# PARTS & SERVICE NEWS

REF NO.	AT99198
DATE	Jan. 6, 2000

**SUBJECT:** REPAIR OF POWER TILT BUSHING ON GD825A-2

**PURPOSE:** To introduce modification procedures for bushings in the power tilting mechanism on GD825A-2 motor graders (undergone the work equipment minor change)

(Fig. 2)

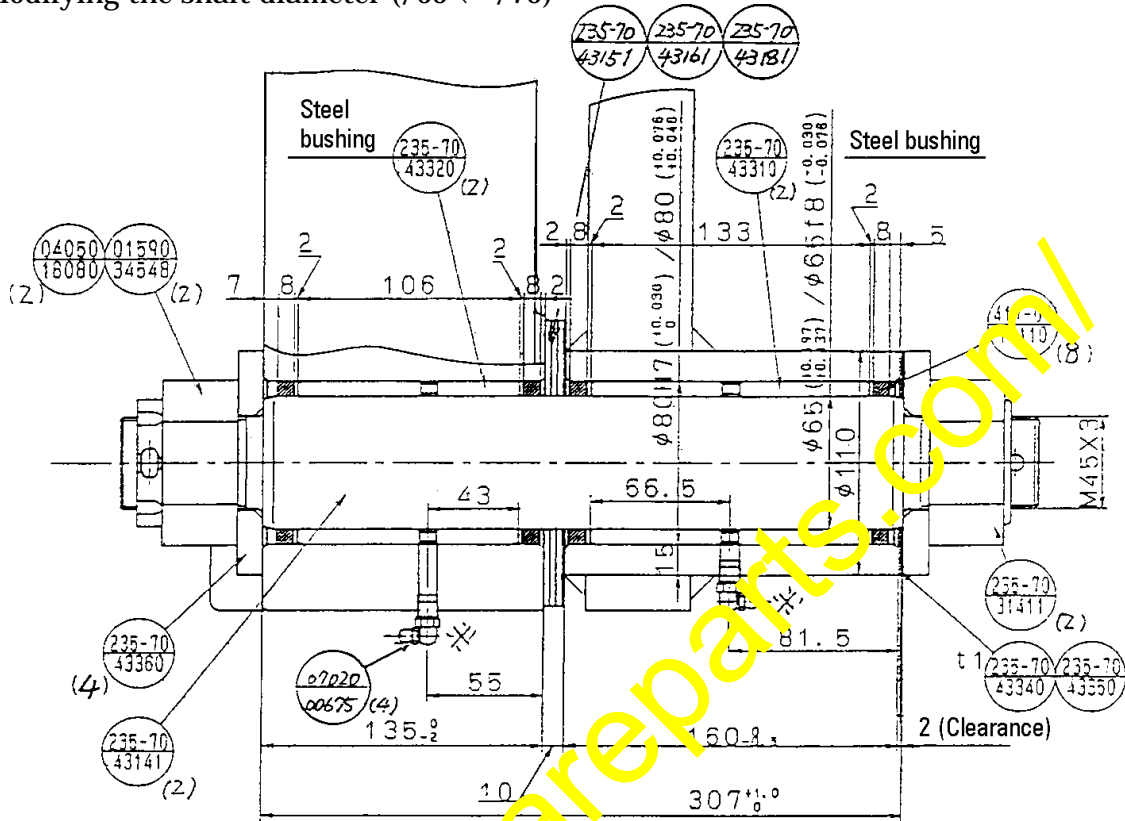
- (1) Changing the DU bushings to steel bushings
- (2) Modifying the shaft diameter ( $\phi 65 \leftarrow \phi 75$ )

(Fig. 5)

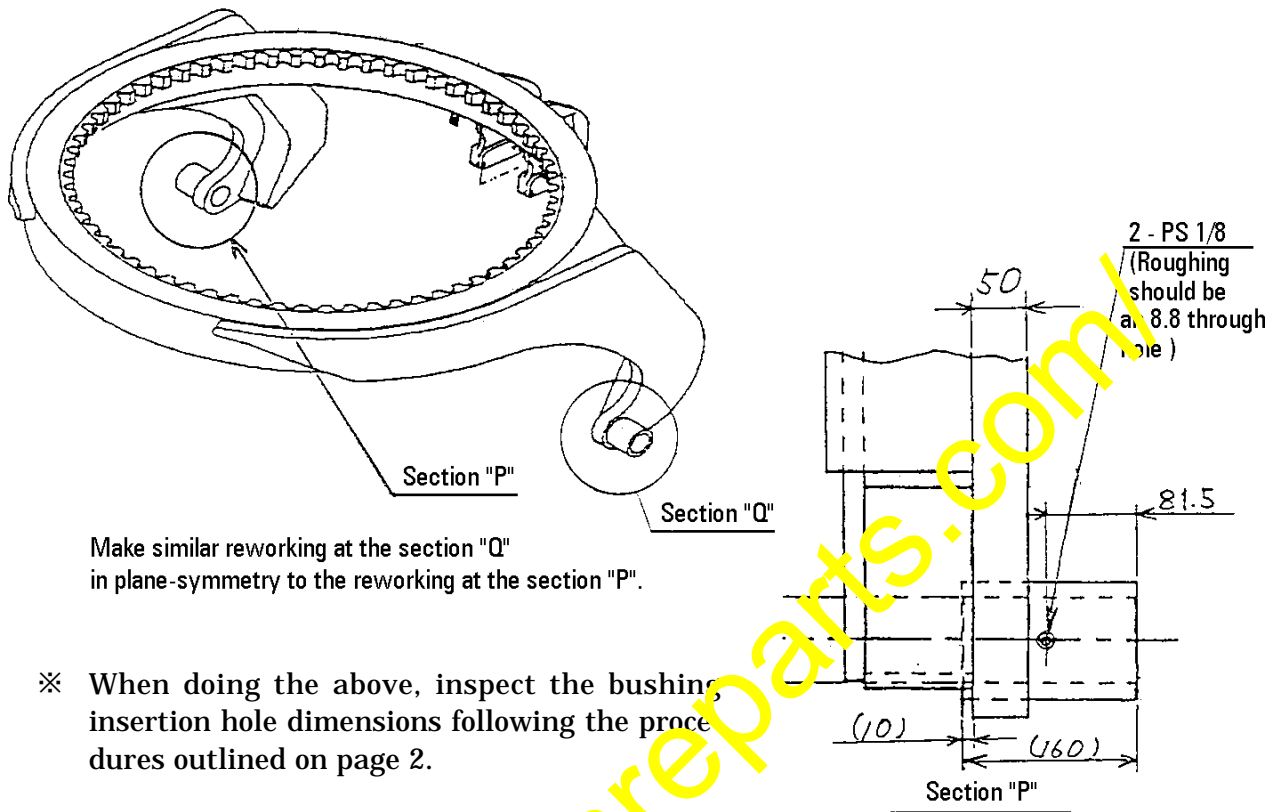
Rework to supplement holes to install the grease fitting in the circle support (on the L.H and R.H sides).

- ※ When doing the above, inspect the bushing insertion hole dimensions following the procedures outlined on page 2.

Blade rail mounting bracket section (Fig. 6)

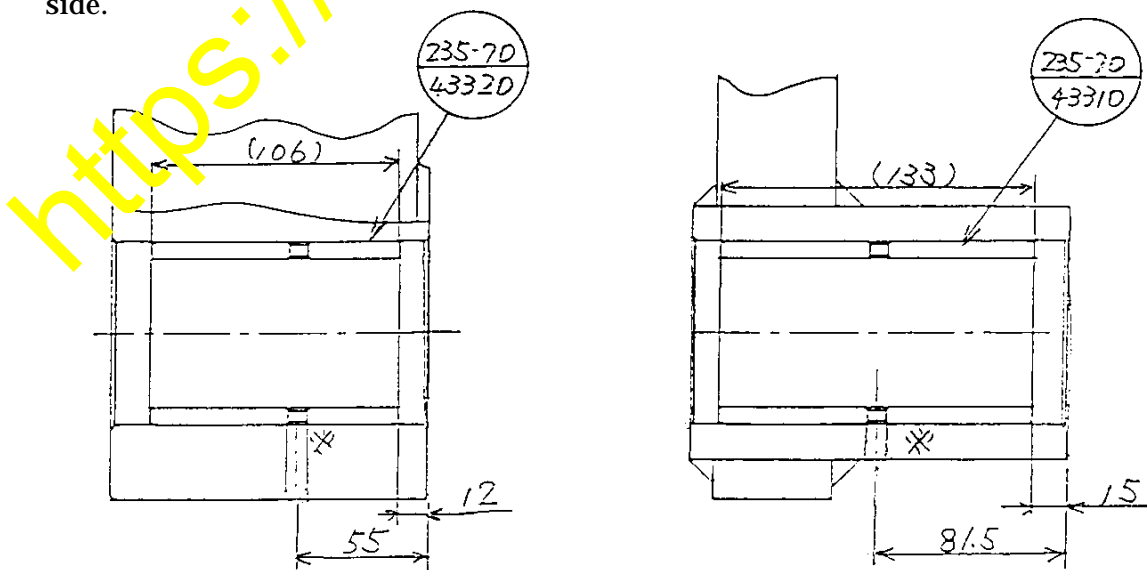
Insert the blade rail mounting bracket bushing and the circle support bushing according to the designations given in Fig. 6 and Fig. 7.

Since the bushings are being provided with greasing hole, align the hole with the grease fitting hole on the blade rail mounting bracket side and on the circle support side.

- ※ The grease fitting holes should face the rear of chassis.

Dust seal dimensions and clearance adjustment dimensions using shims (Fig. 9)

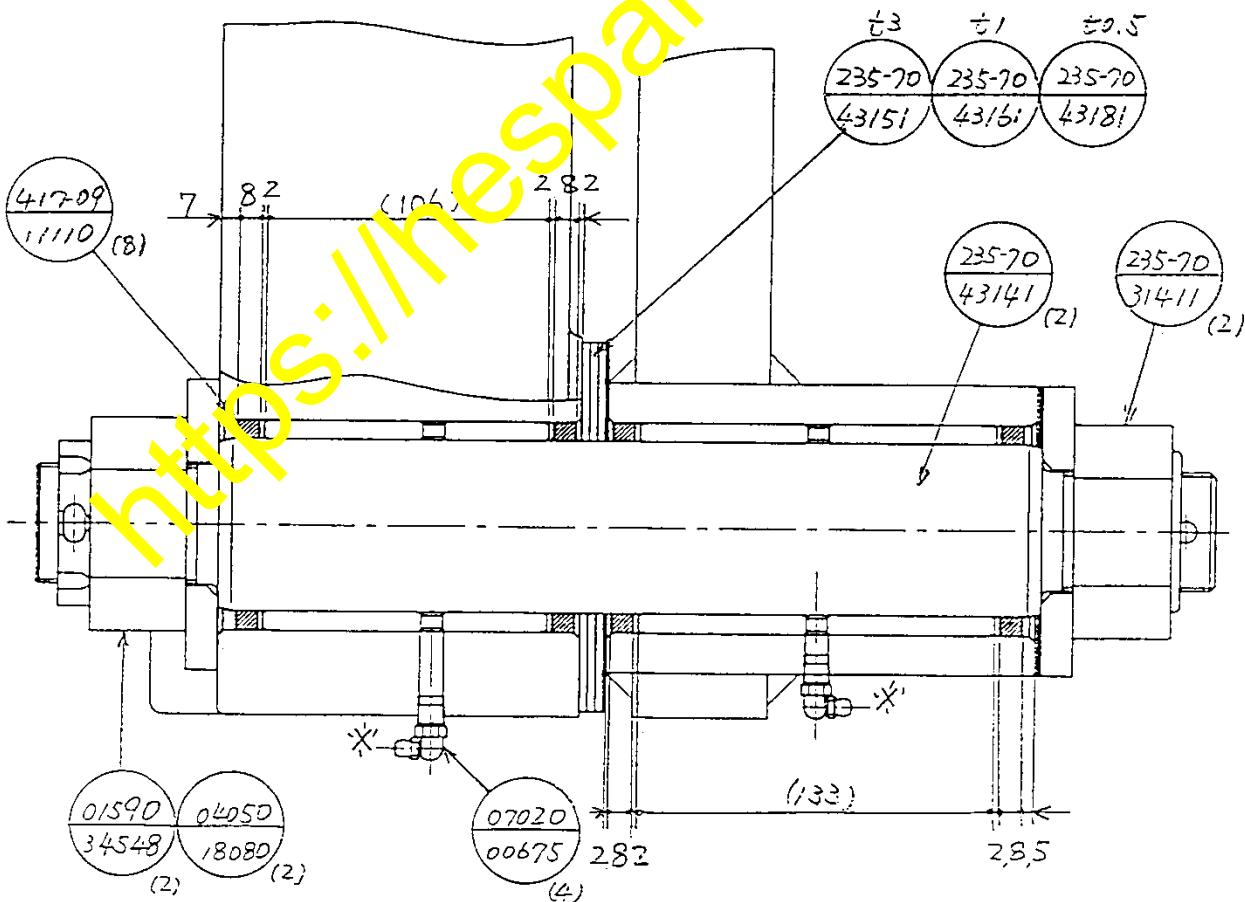
Install the shaft and bushings according to the designations given in Fig. 8 and Fig. 9 and adjust the clearance using shims.

※ Install the grease fitting in the section toward rear of the chassis.

(Fig. 10)

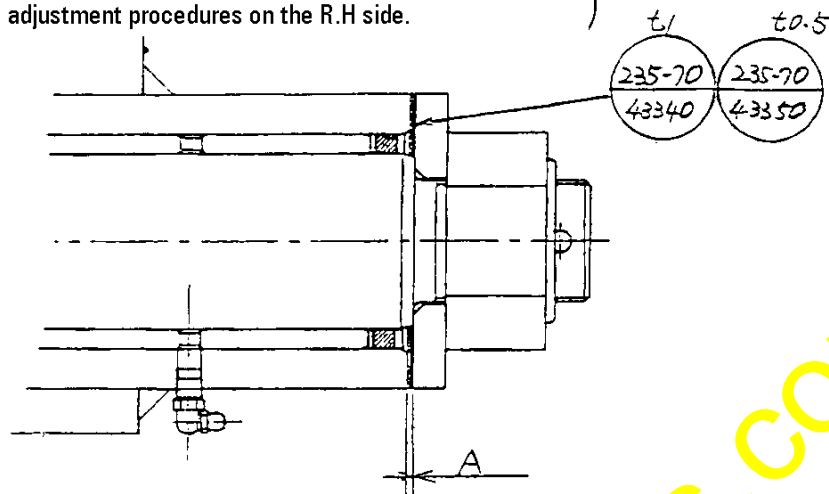
Supplementing shims 235-70-43340 and 235-70-43350, adjust the clearance "A" to 0.5 mm or less.

Reworking dimensions for the blade rail mounting bracket (Fig. 5)

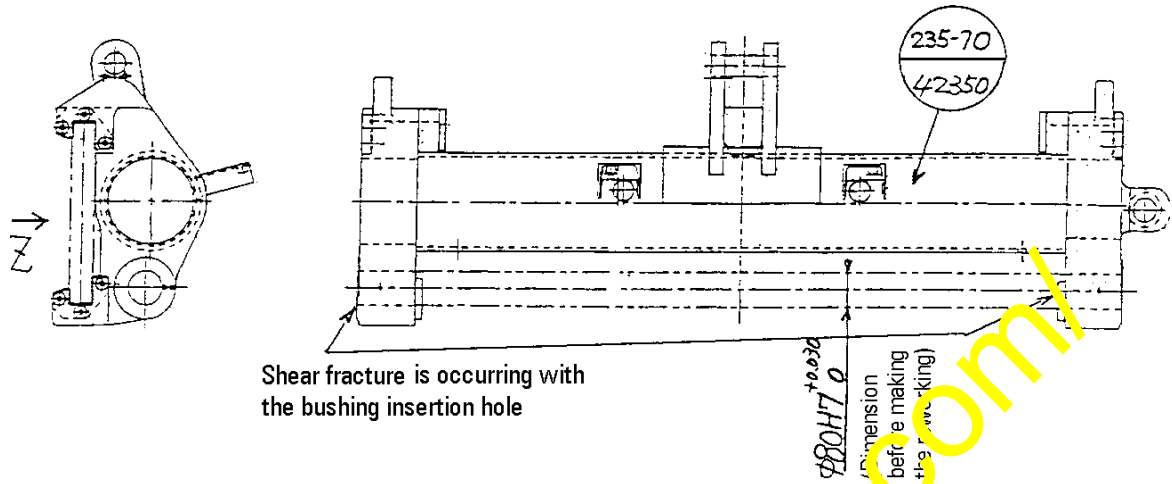
In case the bushing insertion hole is found deformed by partial and excessive contact, rework to the dimensions according to Fig. 5 below.

Shear fracture is occurring with the bushing insertion hole

Blade rail mounting bracket hole dimensions (Fig. 6)

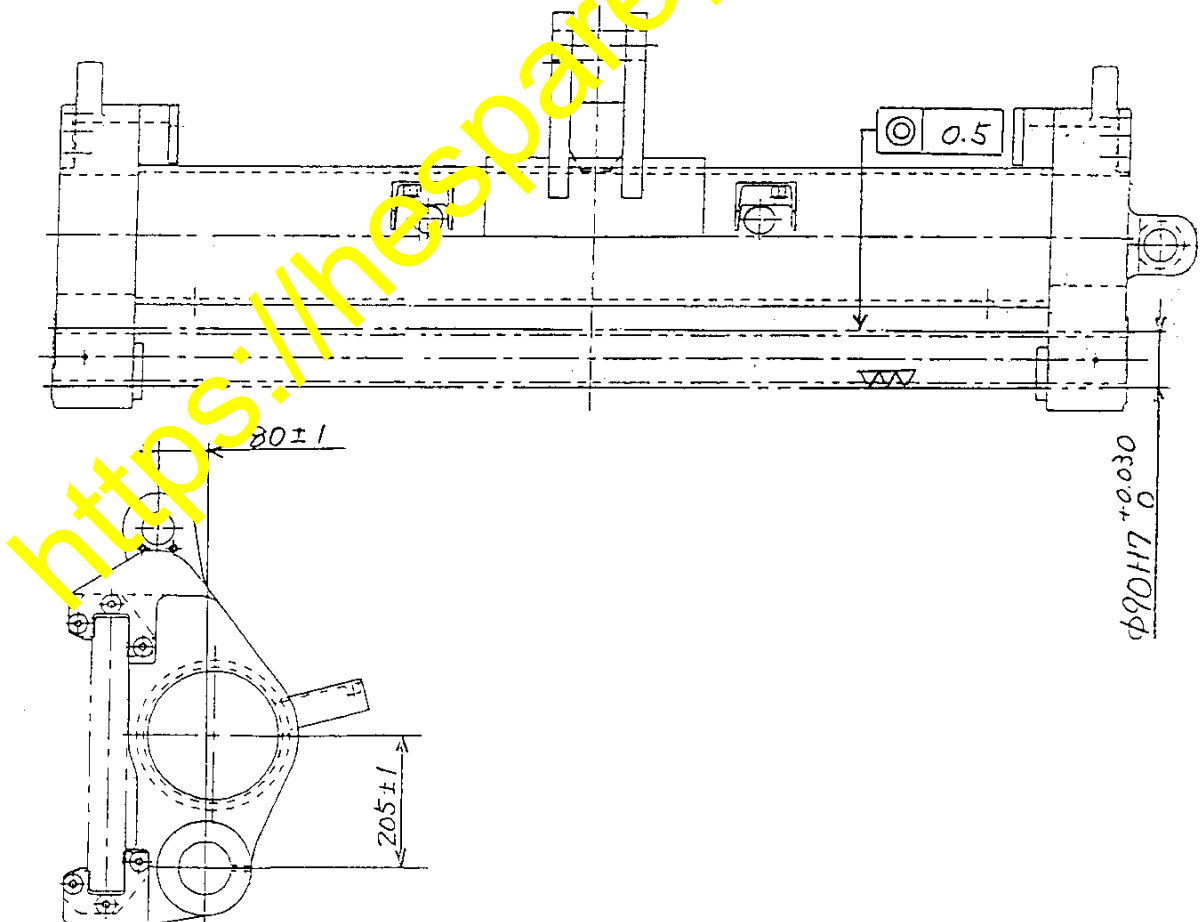
- To cut off the deformed section of the hole, enlarge the hole by drilling to  $\phi 90H7 +0.030/0$ .
- The hole dimension should be according to Fig. 6 below.

Reworking with the circle support (Cutting) (Fig. 7)

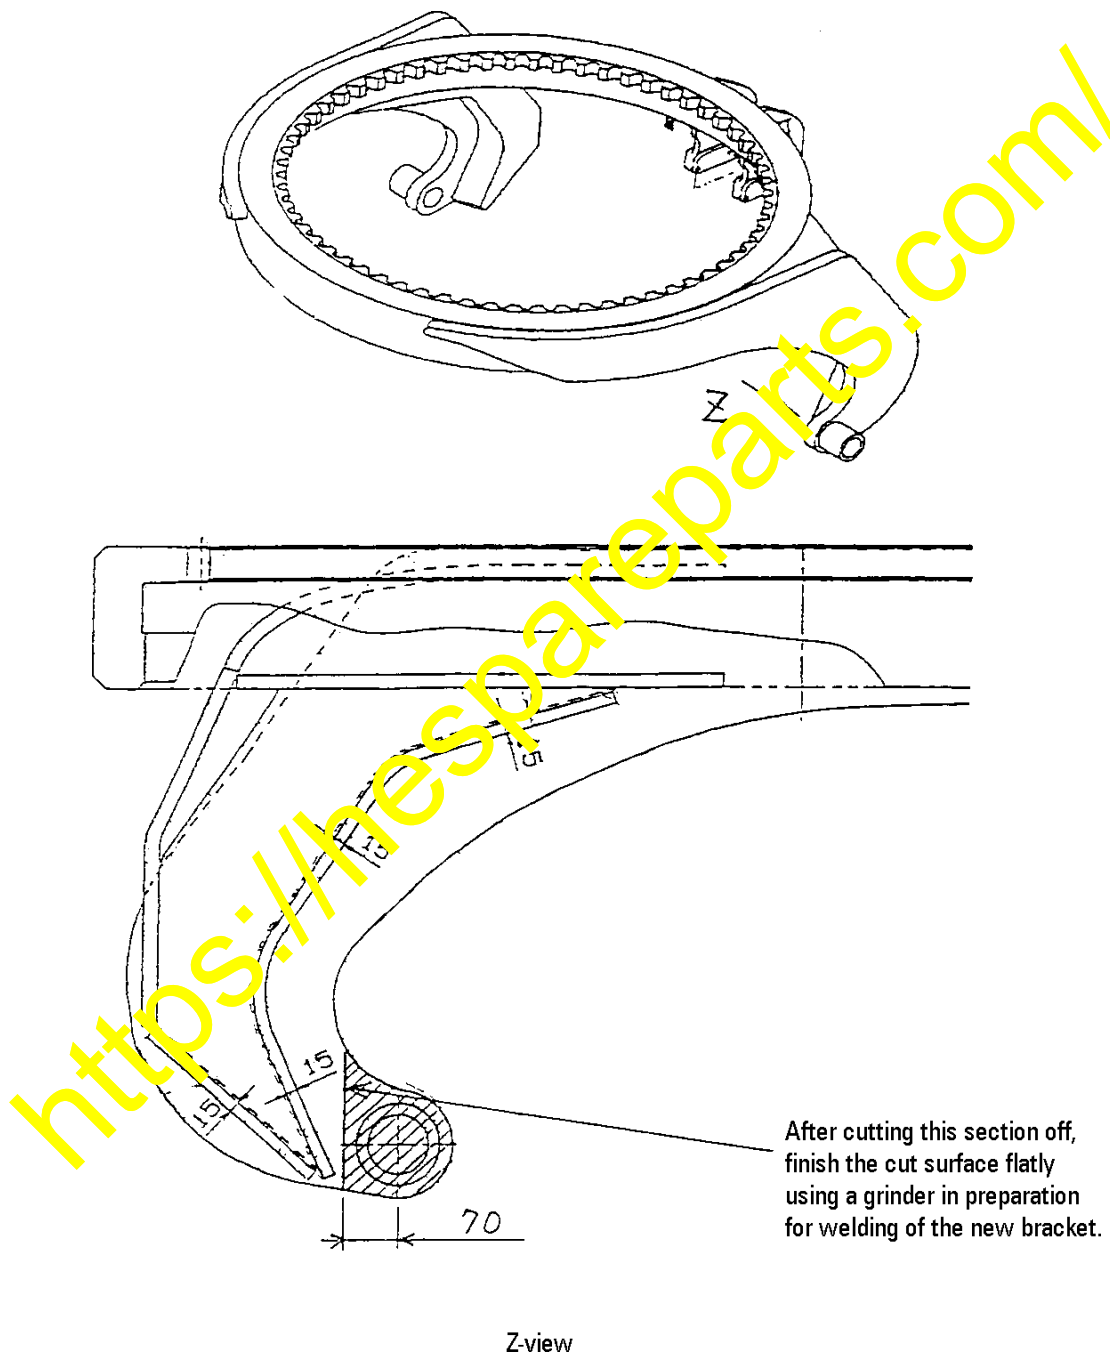
Since shear fracture may be occurring with the bushing insertion hole, cut off to remove the hatched sections according to the designations given in Fig. 7 and weld the brackets 235-99-11910 and 235-99-11920.

Cut off to remove the bushing insertion section of the circle support, namely, the hatched section, according to the designations given in Fig. 7.

Cross-section "A-A" (on the LH side of the circle support)  
 Reworking with the circle support (Welding) (Fig. 8)

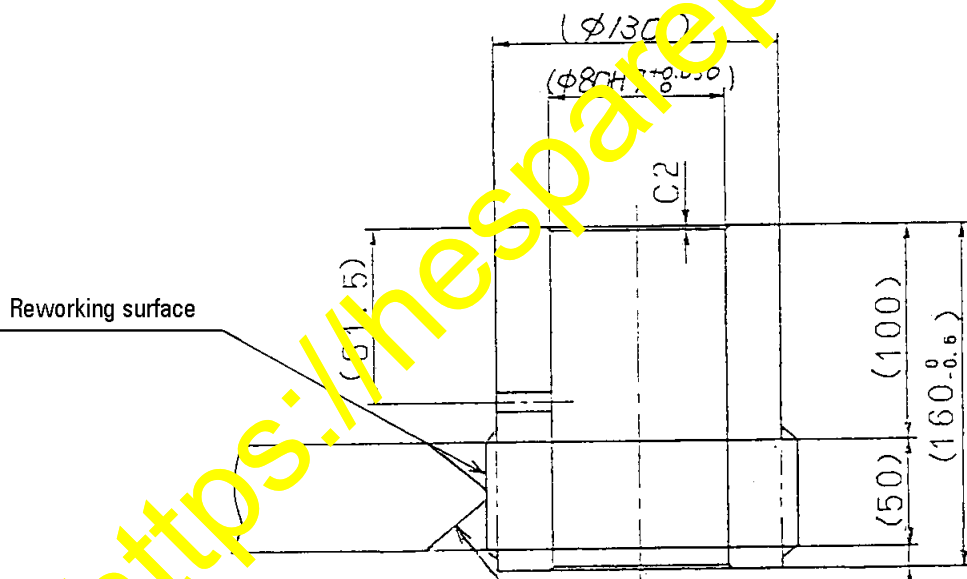
- Providing the welding groove according to the above diagram, weld the bracket 235-99-11910 and bracket 235-99-11920 to the circle support body.
- When the welding work has been done, finish the welded surfaces not to allow any dent using a grinder.

Dimensions after finishing the welding work (Fig. 9)

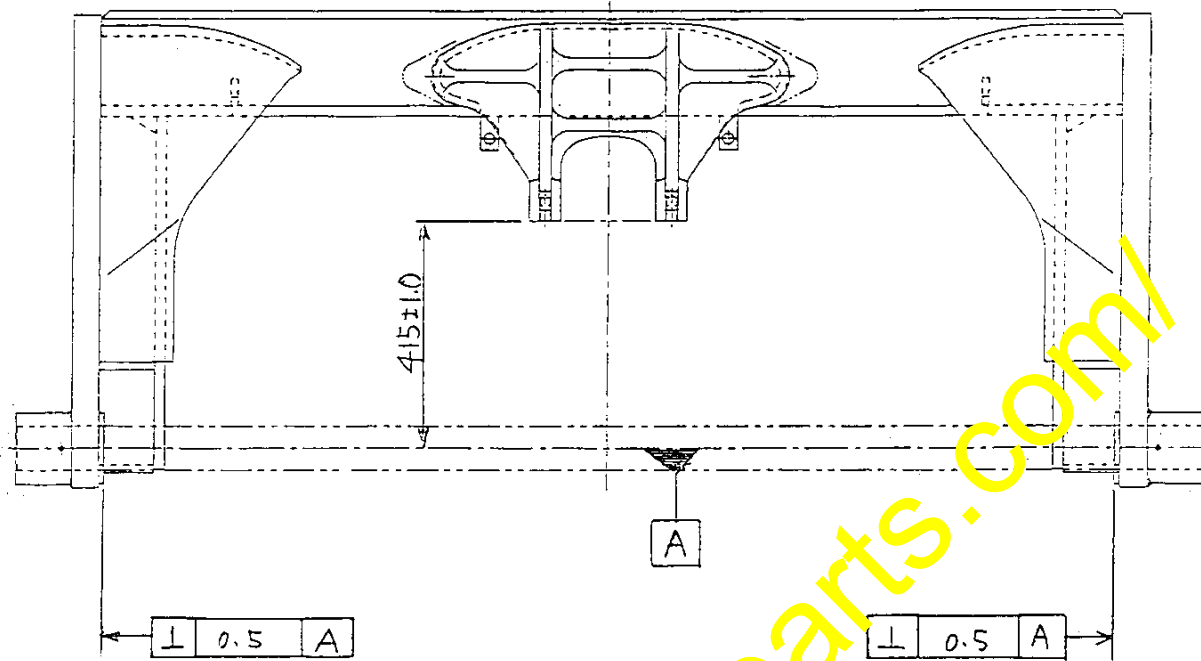
3. Dimensions after finishing the welding work for the circle support  
 Shown in Fig. 9 below are the dimensions after finishing the welding work for the circle support according to "Section 2" on the preceding page.

Blade rail mounting bracket section (Fig. 10) Circle support section (Fig. 11)

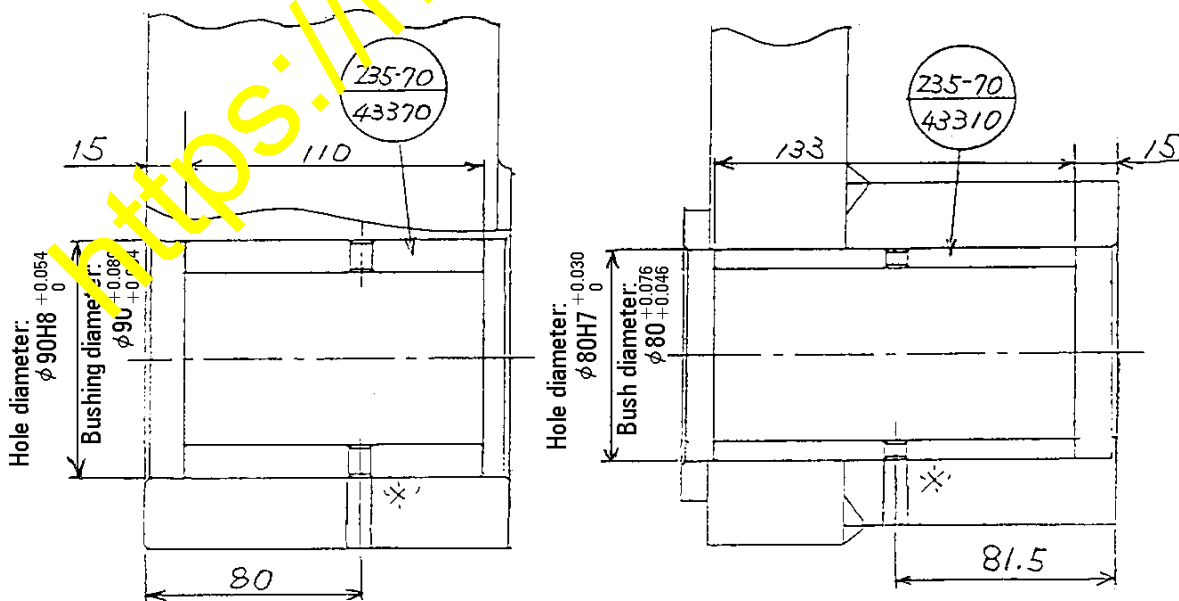
Since the bushings are being provided with greasing hole, align the hole with the grease fitting hole on the blade rail mounting bracket side and on the circle support side.

※ The grease fitting holes should face the rear of chassis.

**Dust seal dimensions and clearance adjustment dimensions using shims (Fig. 12)**

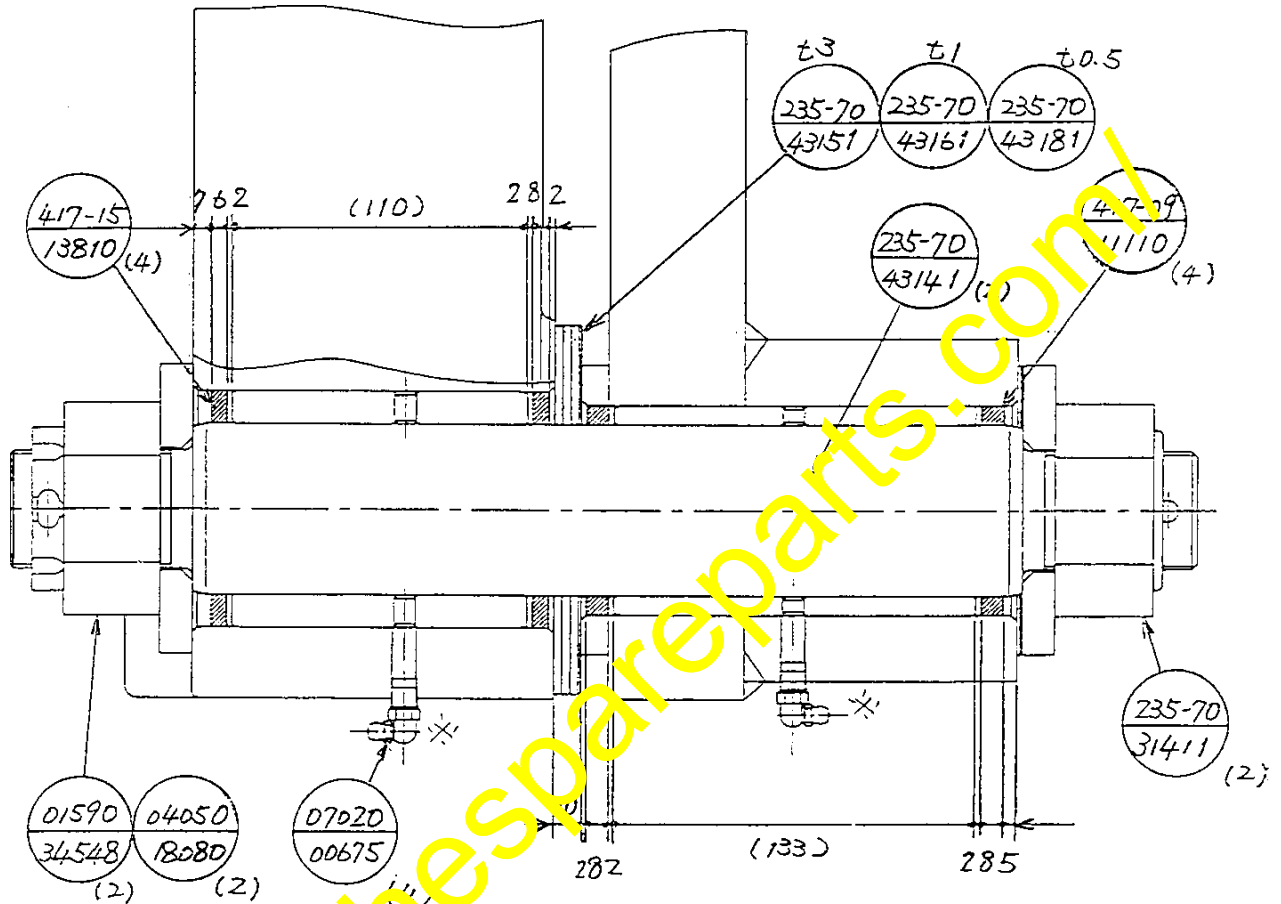
Install the shaft and bushings according to the designations given in Fig. 12 below and adjust the clearance using shims.

※ Install the grease fitting in the section toward rear of the chassis.
